THE SHOPS AT
PIPER GLEN

ALTERNATE SITE PLAN

SUBJECT: Administrative Change to Specific Plans for Parcel #4
of Petition No. 86-4(c)

SUBJECT: Administrative Approval to Specific Landscape Plan for Parcel #4 at
Piper Glen, Part of Petition No. 86-44(c), Tax Parcel No. 225-061-01,
225-011-03, 07, 225-021-01, 225-031-01, 225-041-01, 225-051-01.

THE SHOPS AT
PIPER GLEN

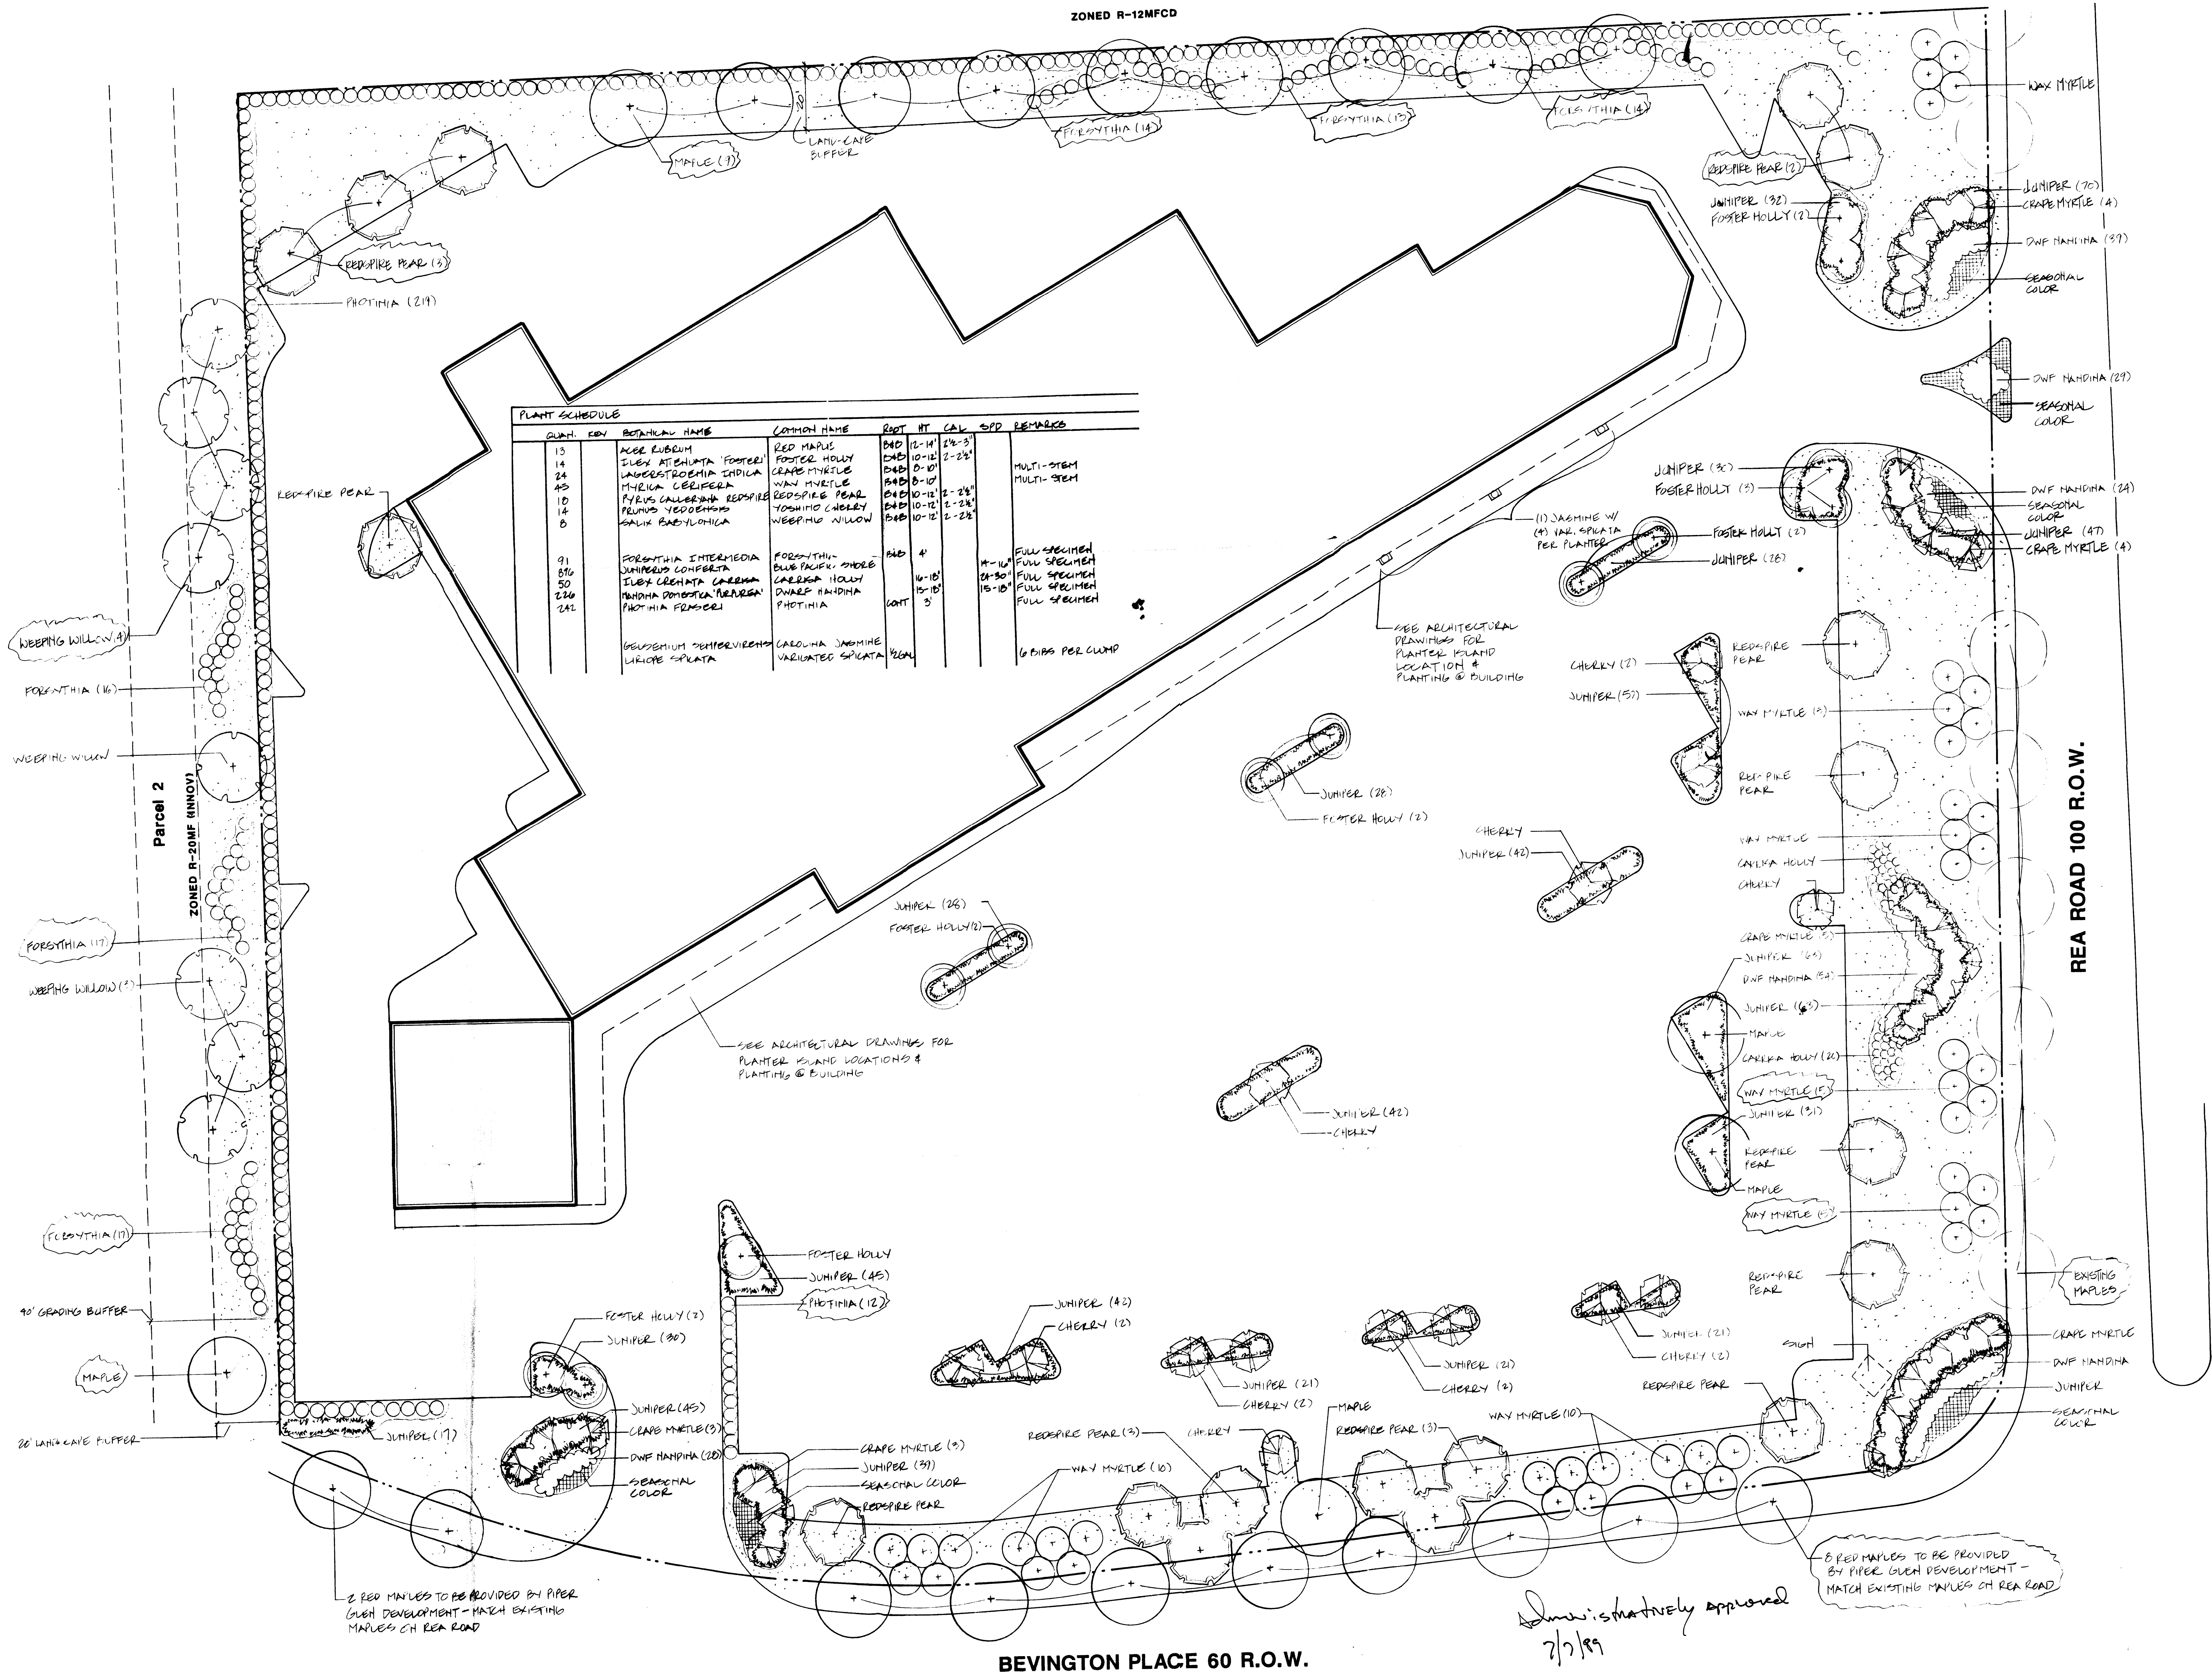
Attached is a set of revised plans for Parcel #4 at Piper Glen. The plan has been revised to show additional square footage and additional parking spaces. Also attached is a revised landscape plan reflecting the changes to the parking areas. Since these changes are minor and do not effect adjoining property I am administratively approving these plans. Please use these plans when evaluating requests for building permits.

THE SHOPS AT PIPER GLEN

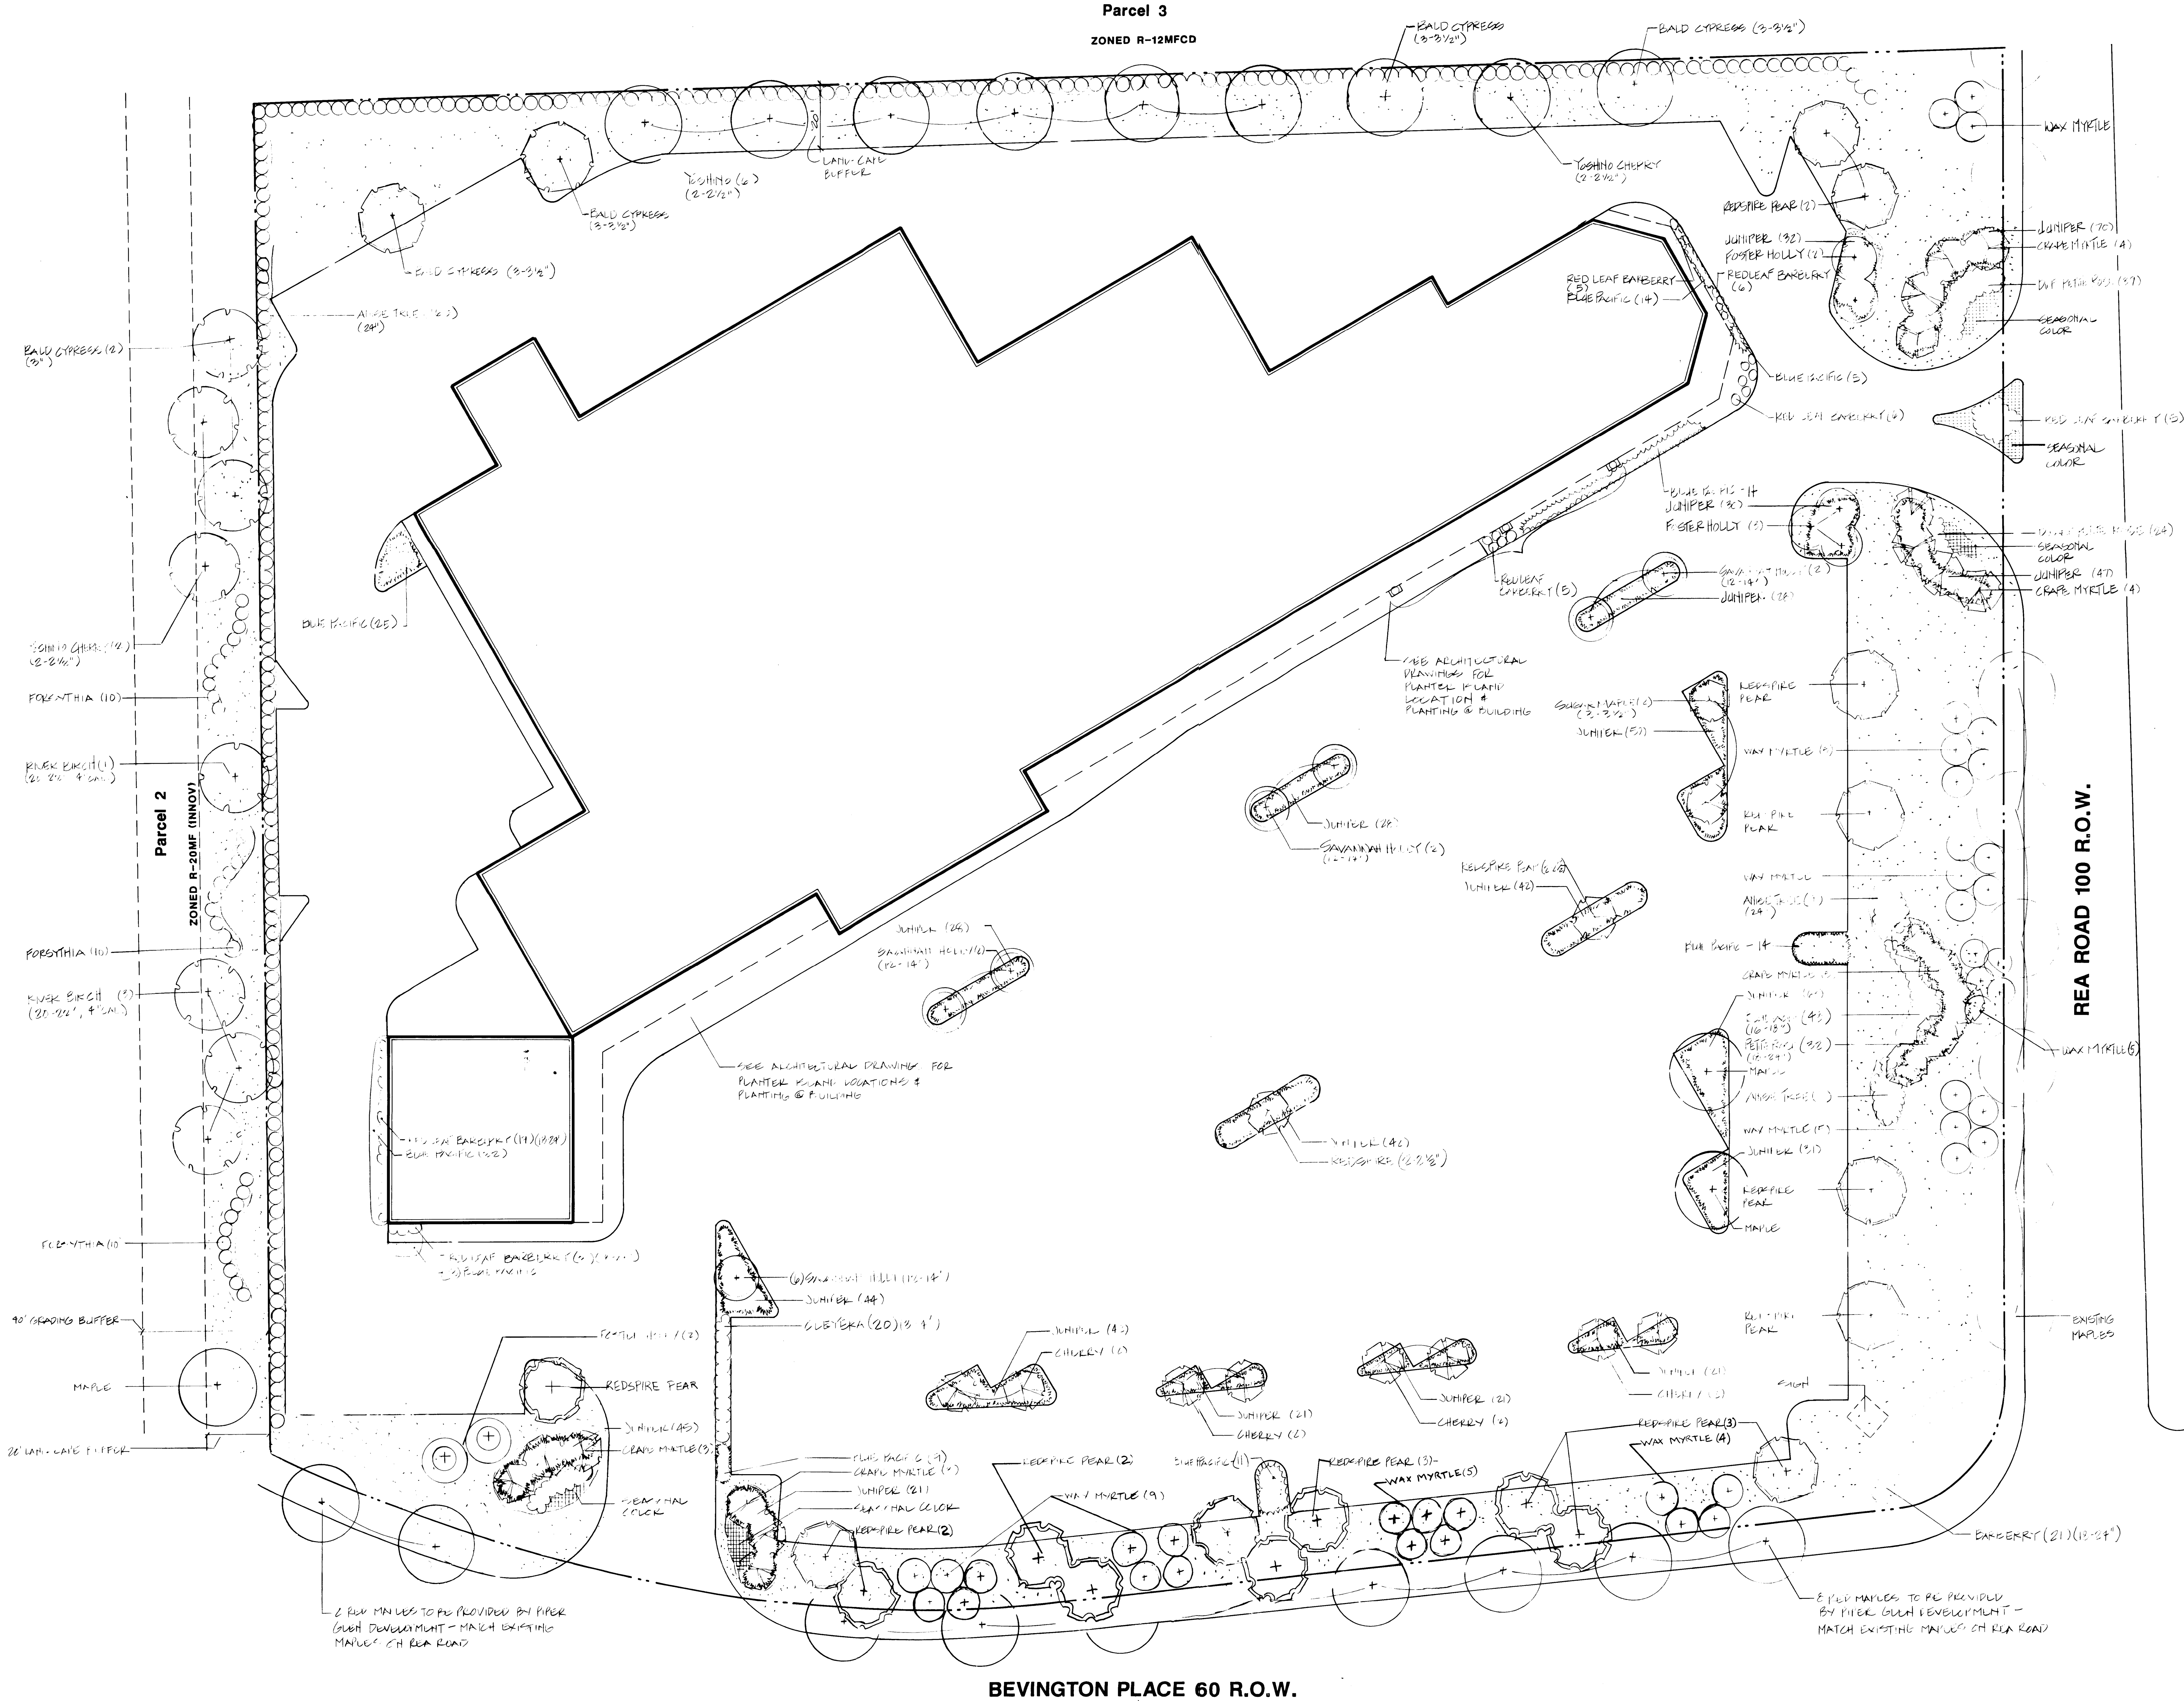
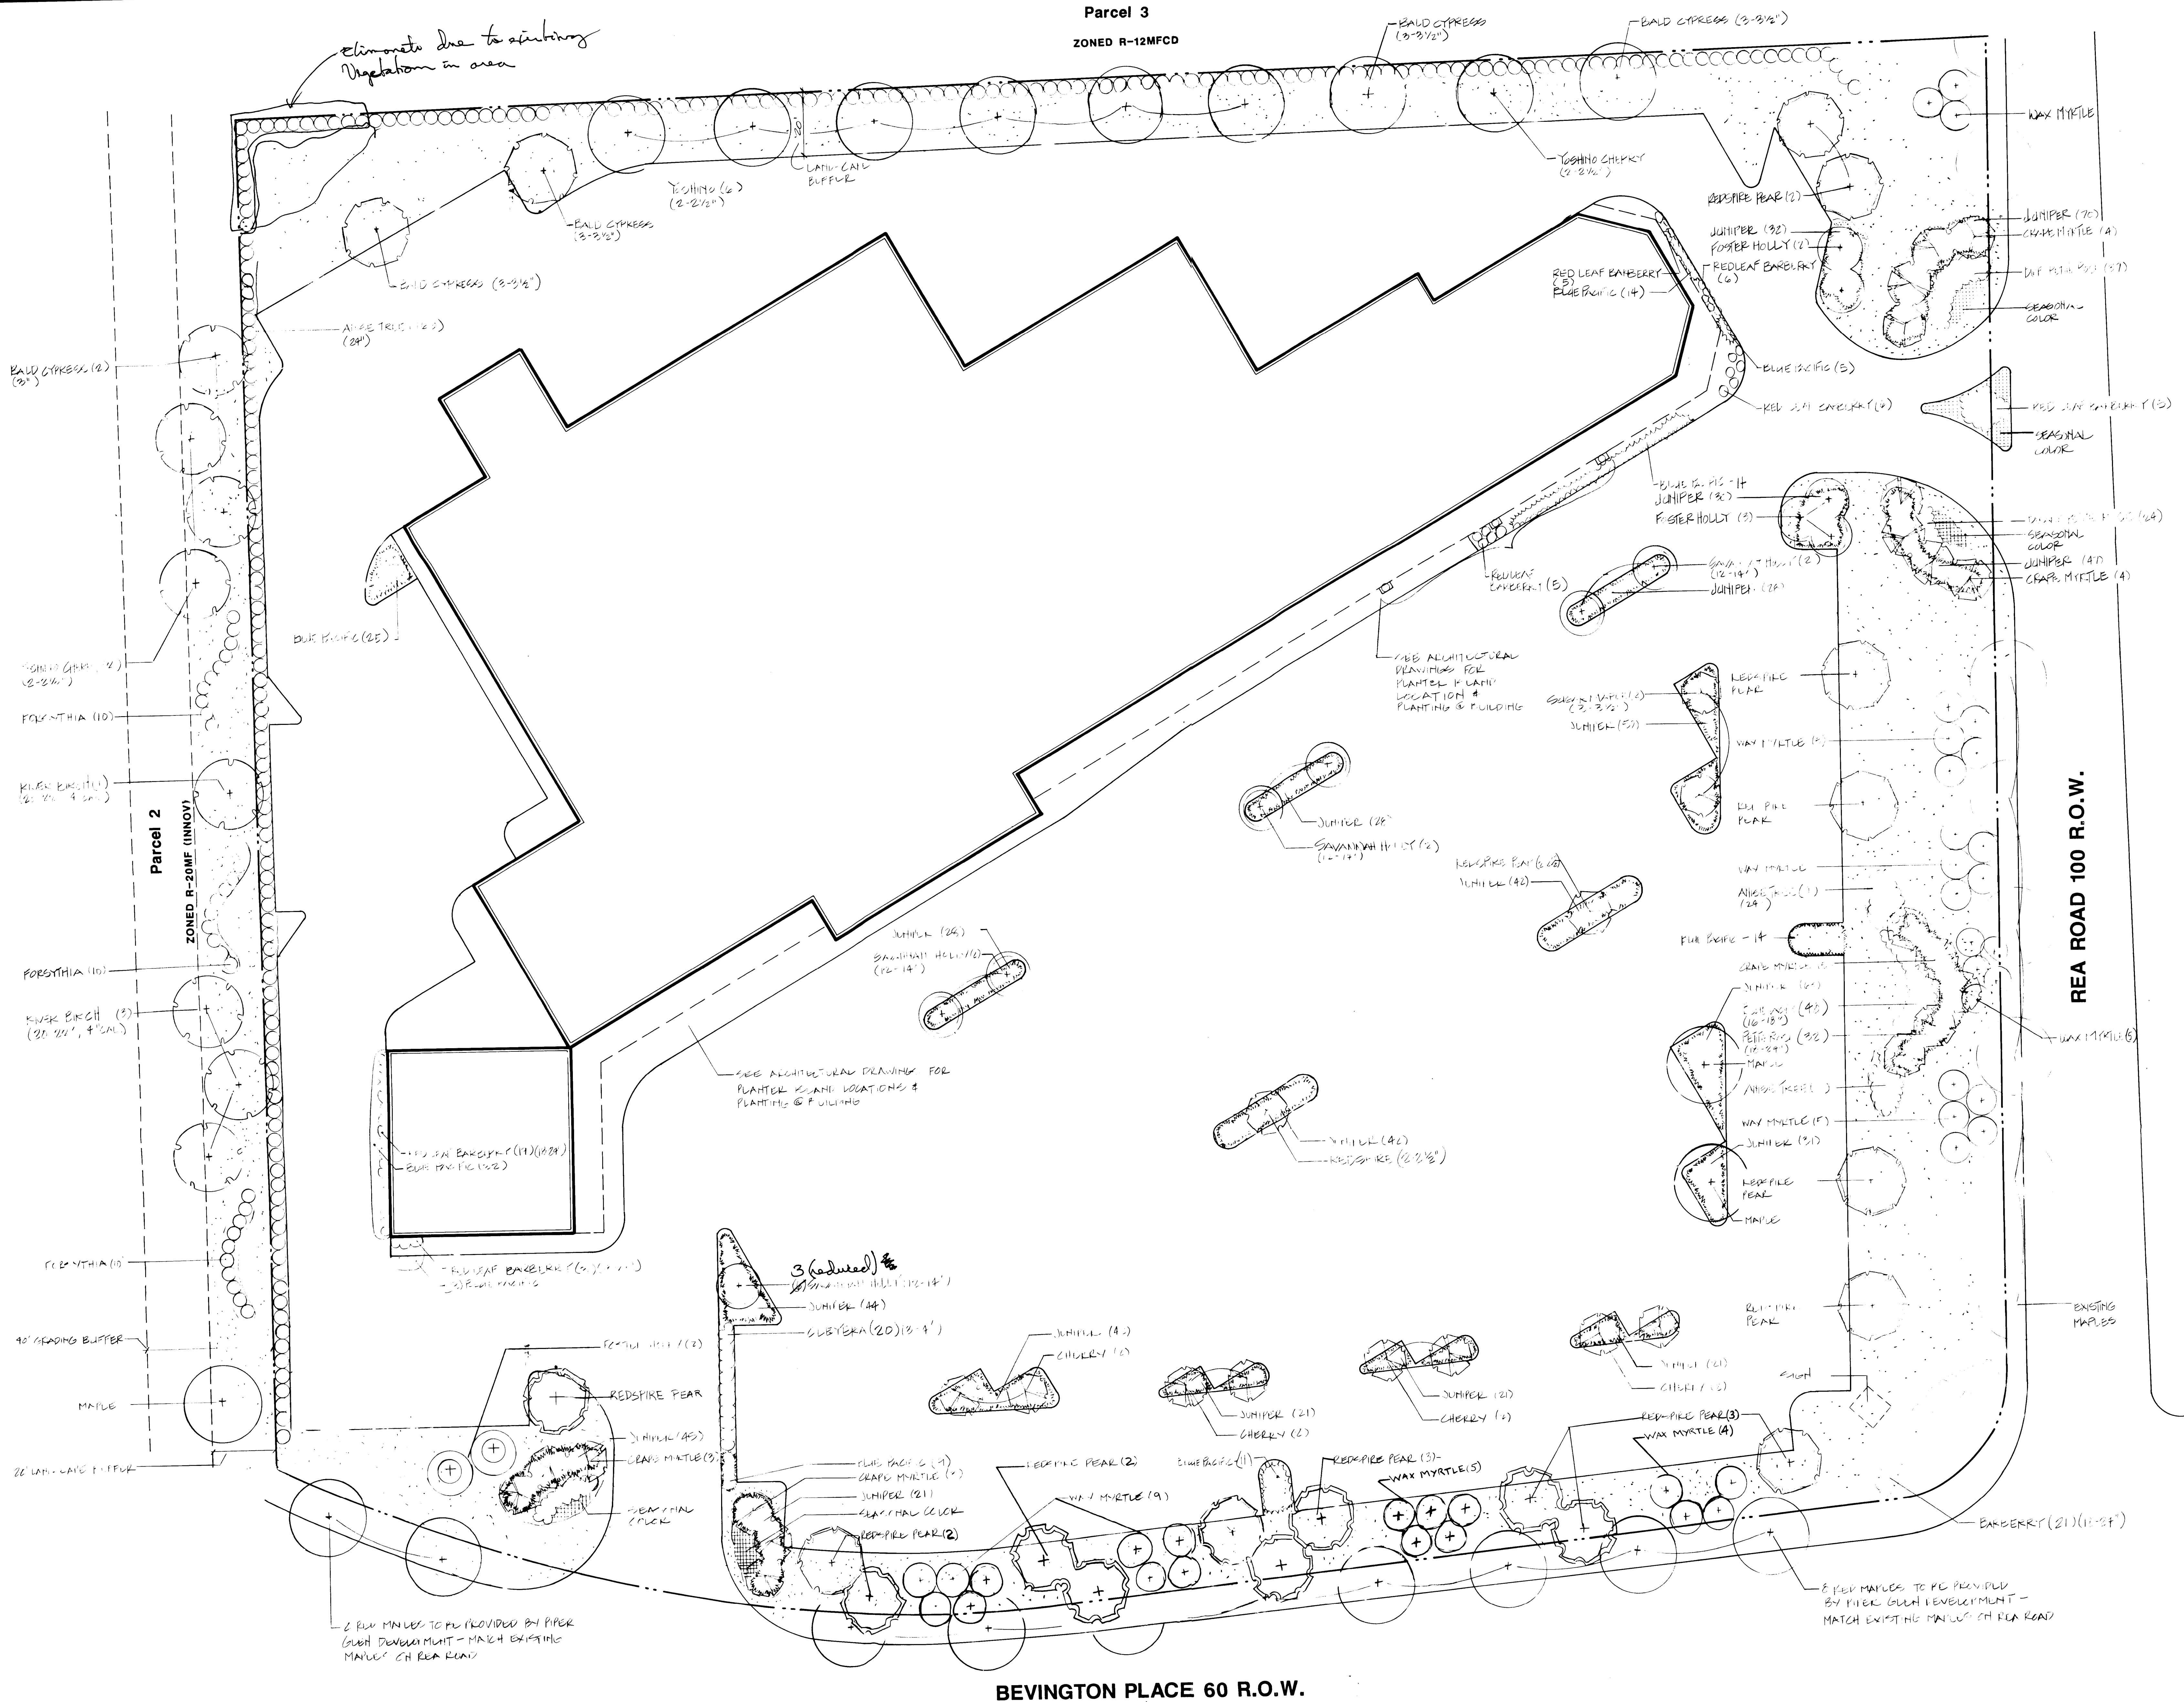
Attached is a revised landscape plan for parcel #4 at Piper Glen. Minor changes have been made to the plan to recognize the existing field conditions. Since these changes are minor I am administratively approving this plan. Please use this plan when evaluating requests for building permits and certificates of occupancy.
